**Advisory Action
Before the Filing of an Appeal Brief**

10/072,707

HOULE ET AL.

Fig. 1

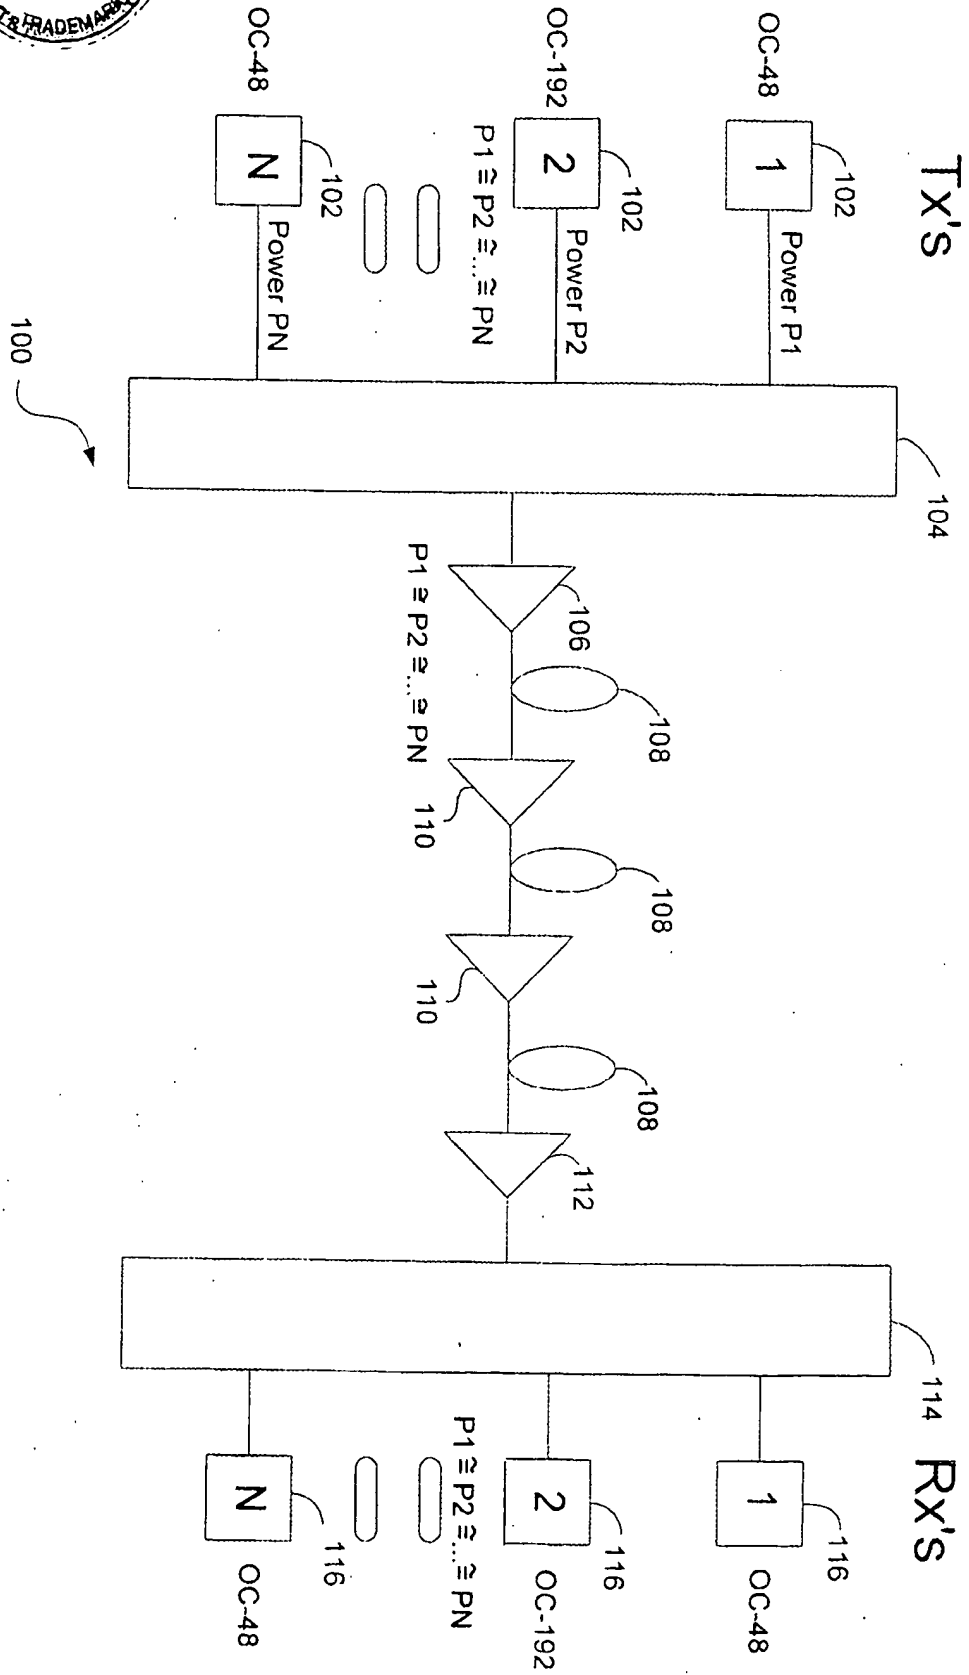
appreciated. Applicant filed a new Fig. 1 on 28 November 2005. This drawing replacement sheet is approved. Although a drawing objection to Fig. 4A was presented in the previous Office Action, the explanation was inadvertently omitted. Examiner objects to Fig. 4A since the labels "OC-48" and "OC-192" are not supported in the specification for the embodiment shown in Fig. 4A. That is, Fig. 4A shows particular data rates, OC-48 and OC-192, for the embodiment that applies error correction coding to multiple data signals. However, the portion of the specification that discusses this embodiment (p. 8, l. 20-22) does not disclose the particular data rates of OC-48 and OC-192. As a remedy, Examiner respectfully suggests removing these labels from Fig. 4A.
